**DEVIATION REQUEST
AND DECISION FORM**

Project Name : Hillside at Lorson Ranch
 Schedule No.(s) : 5500000370, 5500000371, 5500000405, 5500000281, 5500000282, & 5500000283
 Legal Description : See Attached

**DEVIATION 2
EXHIBIT**

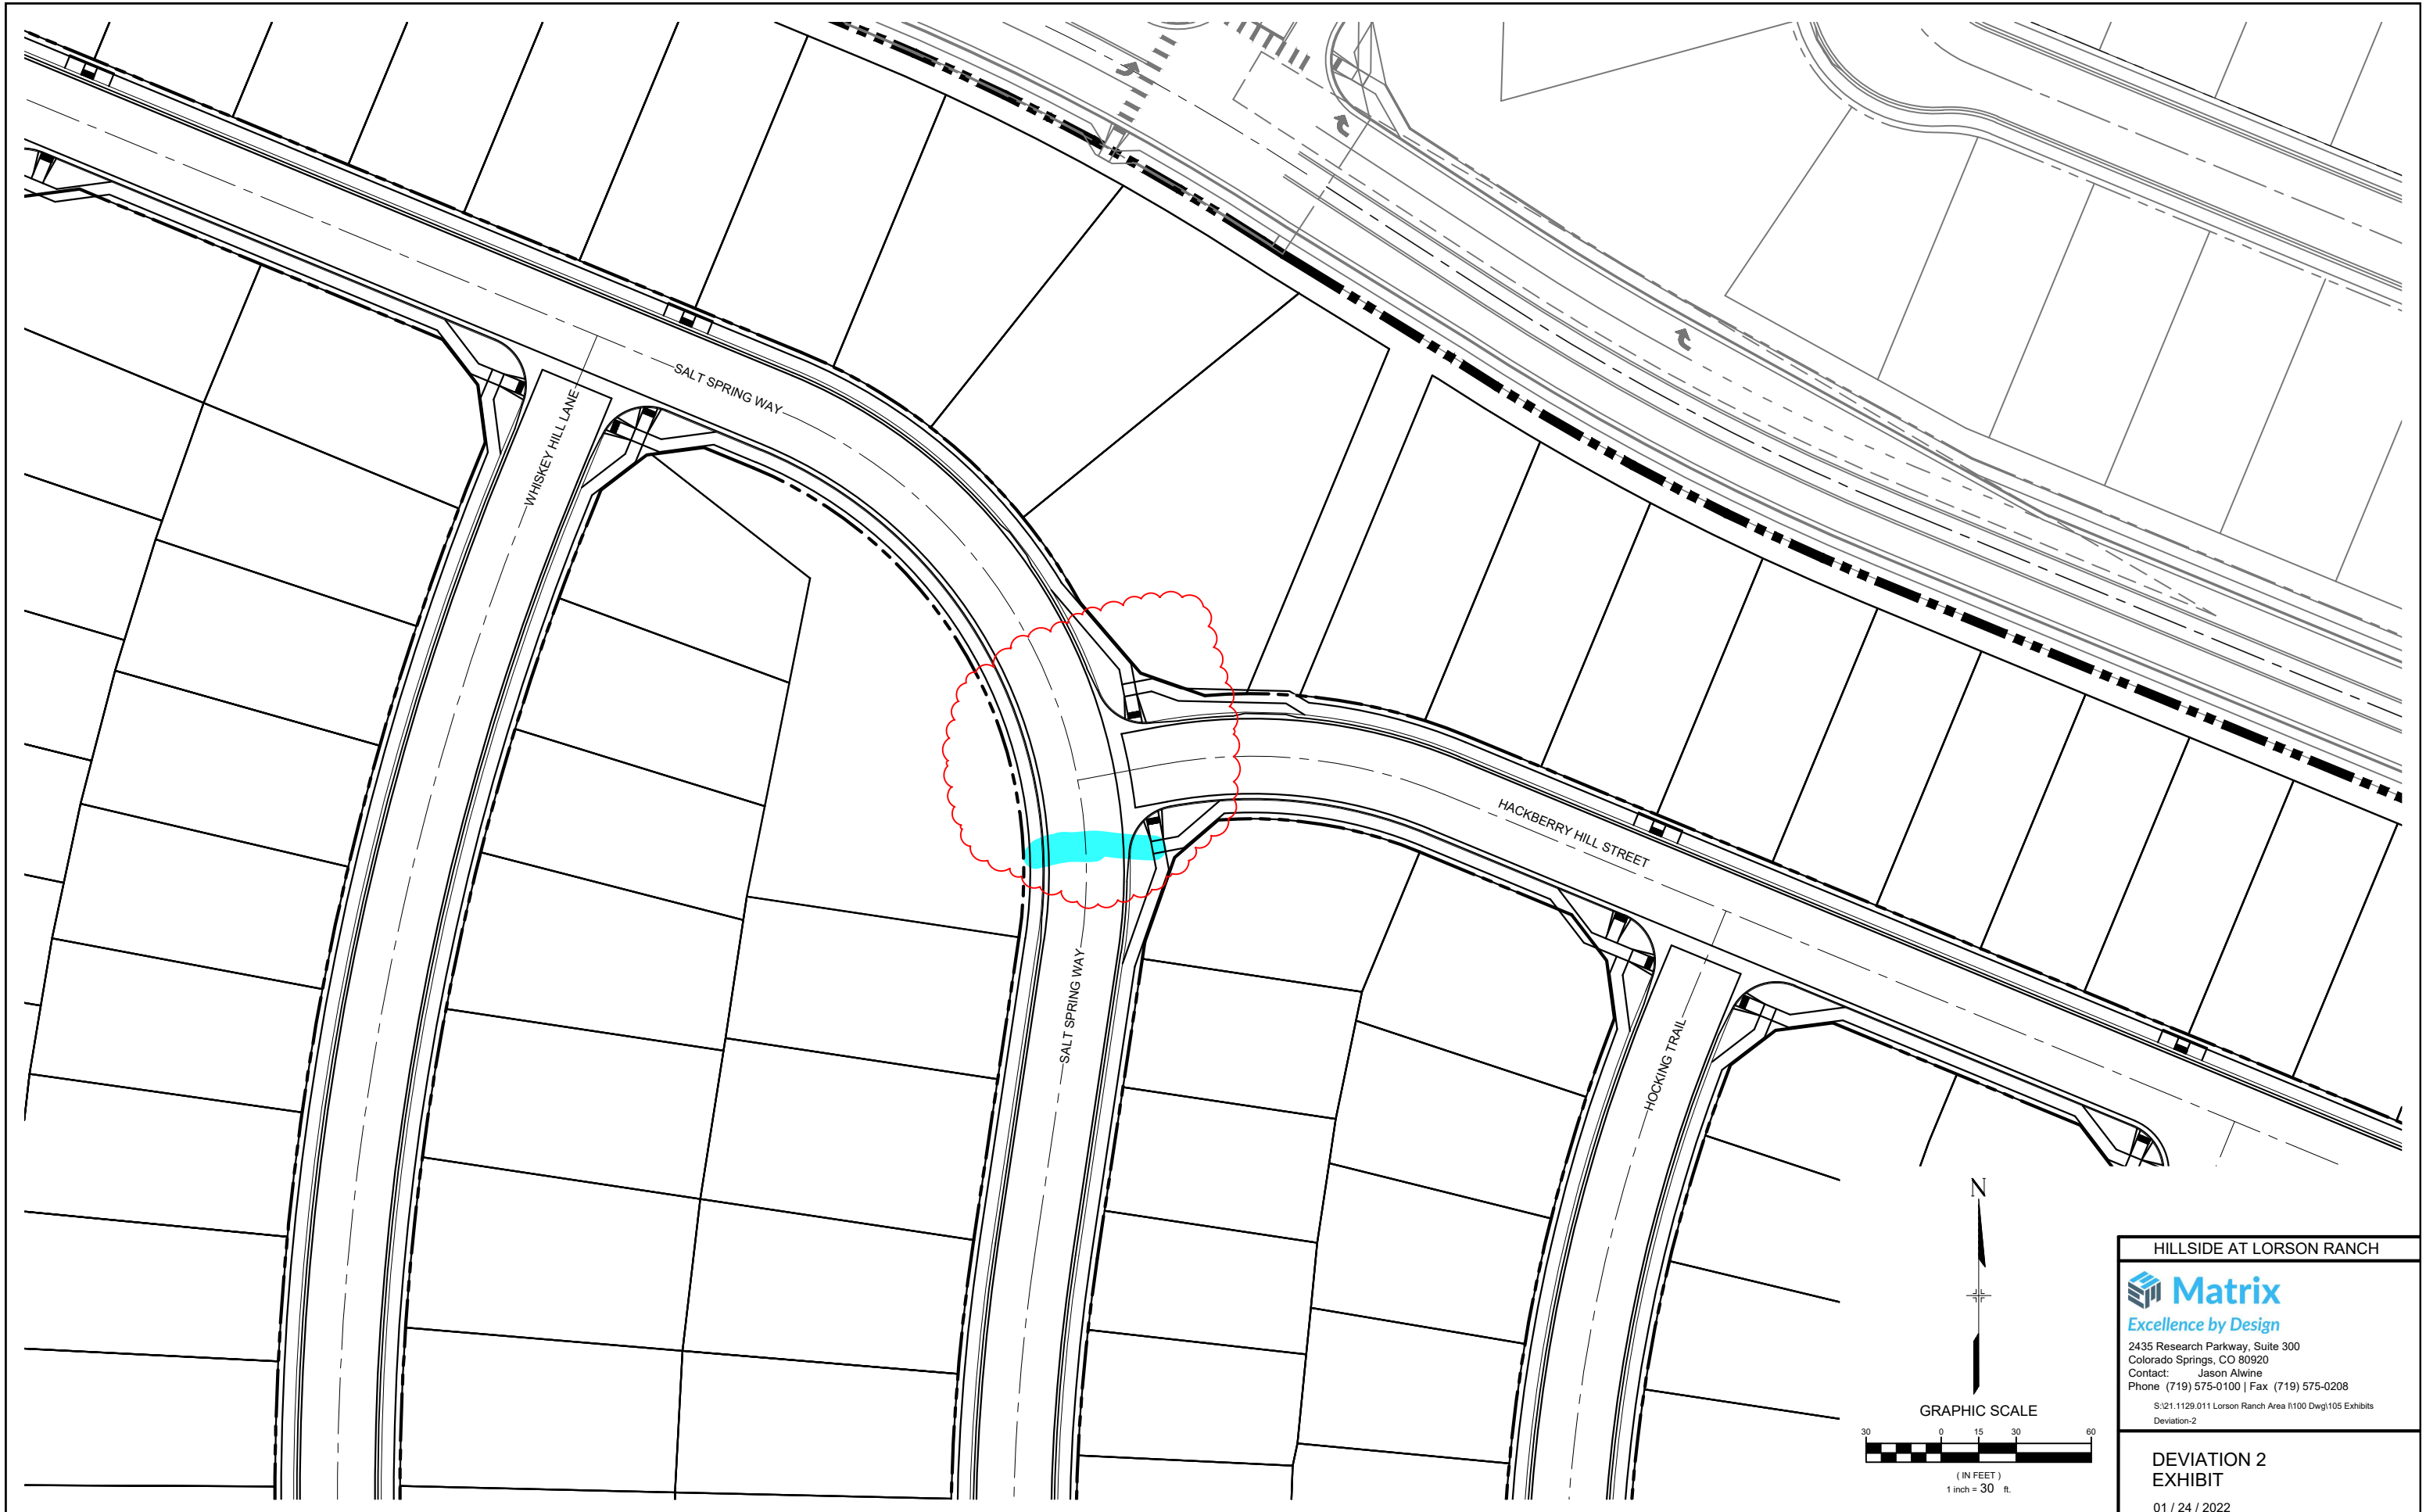
Allow only two pedestrian ramps to be constructed at the T-intersection of Hackberry Hill Street and Salt Spring Way.

The proposed alternative is to construct two pedestrian ramps crossing Hackberry Hill Street and no ramps crossing Salt Spring Way at this T-intersection. The ECM standard is for T-intersections to have a minimum of four curb ramps.

The intersection is in close proximity of other intersections with all the required ramps constructed. Installation of an additional two ramps at this intersection is not feasible as the grading cannot meet ADA requirements along the ADA curb returns. The additional ramps may also be a safety concern as the removed crossing is in the middle of a large curve. The crossing at Salt Spring Way and Whiskey Hill Lane is approximately 225' feet away and provides a much safer intersection for pedestrian movements.

Elimination of **two** of the **four** ramps at this intersection will not impede pedestrian movements and will result in safer pedestrian crossing due to grading concerns and the inability to meet ADA slope requirements (where required). The additional ramps may also be a safety concern as the removed crossing is in the middle of a large curve. A pedestrian will be able to cross at alternate locations within approximately 225' of the eliminated ramps.

3 for a T
intersection
